INDESIT company

Model type:
WAS6XIT

Commercial code:
F027052

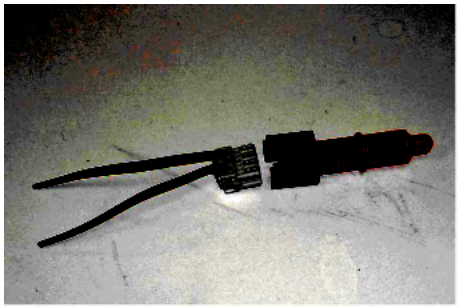
The premodification wirings, are also managed for modified products by making the connection to the terminal block of the new cable as shown in fig. 1 - 1D.
The wiring diagrams given in the Documentation remain unchanged.

FIG. 1

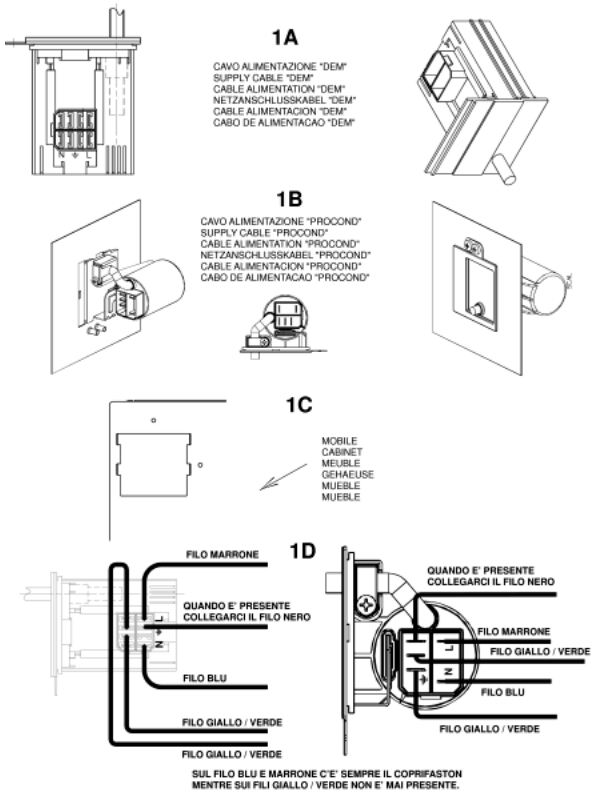
- EEPROM (the OKO system requires a new setting of load timing parameters). THE NEW EEPROMS REPLACE ALL THE ONES CODED PREVIOUSLY.
- BOWL (hopper tube hole shifted forwards);
- DETERGENT LOADING TUBE (see fig. 1);
- PRESSURE SWITCH (changed levels);
- OKO PUMP BOWL BLOWER + BALL (see fig. 2A, 2B and 2C);
- CONDUCTIVITY SENSOR (if provided, it is shorter than the premodification item);
- DRAIN PUMP (without detergent collecting tube connection);
- HOPPER (shifted in front of detergent loading tube connection). Fig. 3A post-modification. Fig. 3B premodification);
- AIR TRAP (different shape);
- PRESSURE SWITCH TUBE (different length);
- DRAIN TUBE STOP (specific);

In particular, the OKO system consists of a spherical plastic component inserted in the tube that connects the bowl to the drain pump (see fig.2 A).
At the beginning of each wash cycle the washing machine fills water for 10 seconds and activates the drain pump for 2 seconds. In this way, the water level in the bowl is different from that in the drain tube; this difference increases the thrust of the ball upwards, closing the bowl-pump connection tube hermetically (see fig. 2D).
This system has the double advantage of:
1) separating the wash water and the water in the drain hose, thus saving energy during the heating phase;
2) and ensuring optimal use of all the detergent.
With the introduction of this new component, the detergent collecting tube is no longer required and the pump has one hole only

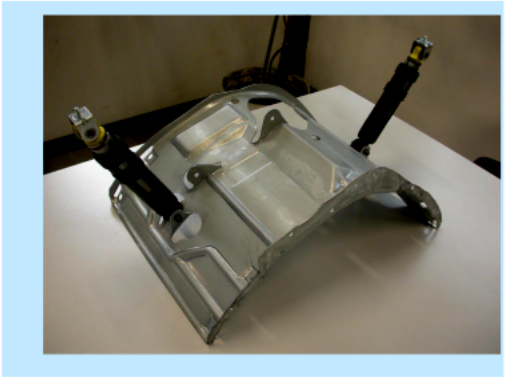
To remove the shock absorber from the tank, first extract the pin with a few hammer taps (see fig.03) until it is aligned with the tank bracket and then pull it out with a pair of pliers (see fig. 04).
(To refit the shock absorber use a new pin. Insert the pin until the toroidal edge is aligned with the bracket.)
